Subject:
15602 Benedict Ln
Los Gatos, CA 95032
PRE21-01290
Property Owners: Alireza Mirbagheri & Shadi Zomorrodi
Architect: Azadeh Masrouf (AMS design LLP)

This is to provide a response to the Consulting Architecture Report dated April 8, 2022 signed by Larry L. Cannon from Cannon Design Group regarding the project referenced above. Several items were identified by the consulting architect to be addressed, and our response for each item can be found in the following pages.

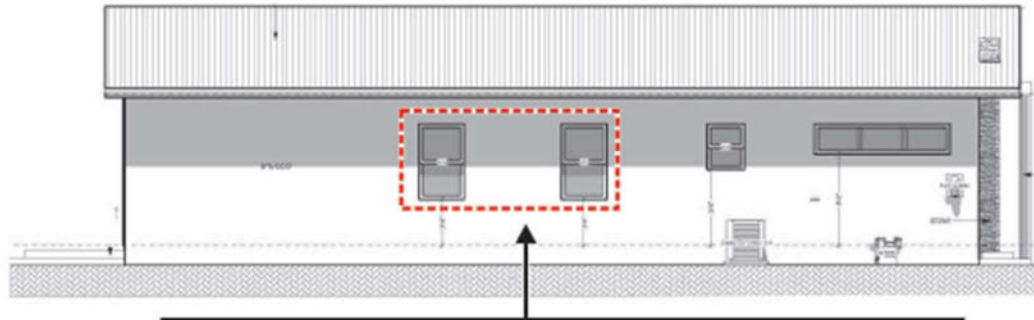
The windows styles and proportions lack consistency which is not consistent with Residential Design Guideline 3.7.2.

Varied window types are not consistent not consistent with the architectural style and Residential Design Guideline 3.7.2

These recommendations were reflected in the new plans submitted.

Nearby home on a street behind Benedict Ln (104 Oak Park Dr)

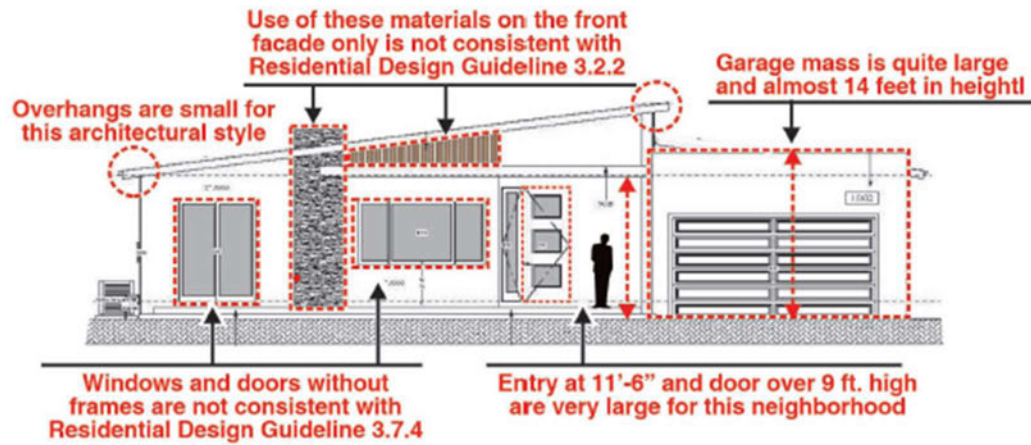
Windows and doors without trim are not consistent with Residential Design Guideline 3.7.4.

Per residential design guideline 3.7.4, window trims are encouraged on stucco houses unless the window frames are recessed. Since our windows design will be recessed, additional trims will not be added. We currently plan to have a maximum of two inches of recess on the windows. It's also worth mentioning that there are several other homes in the neighborhood with very similar windows to our planned design (frameless and with recess much smaller than six inches). Pictures of some of these examples can be found below:

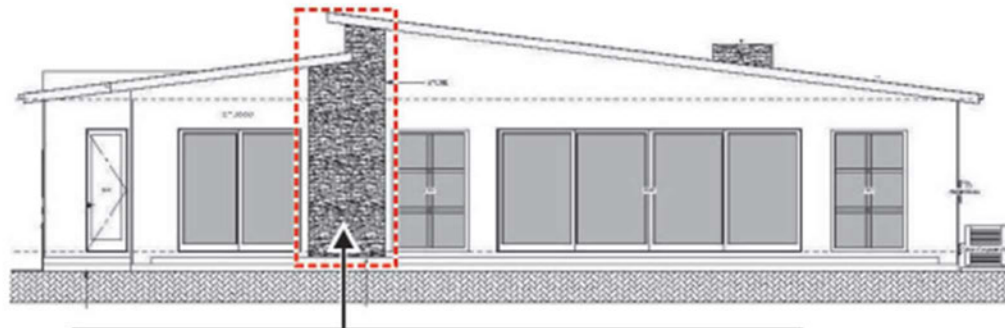
Consider adding translucent windows adjacent to the entry door.

Per current plans, there is a closet behind the wall next to the entry door. From inside of the house, this space in the closet is needed, which doesn't allow adding a window on this wall. From the outside, our plan is to have something in front of this wall adjacent to the entry door to cover the empty space of this wall (such as a large plant, etc.). Therefore, having a window on this wall won't be planned to be implemented at this time.
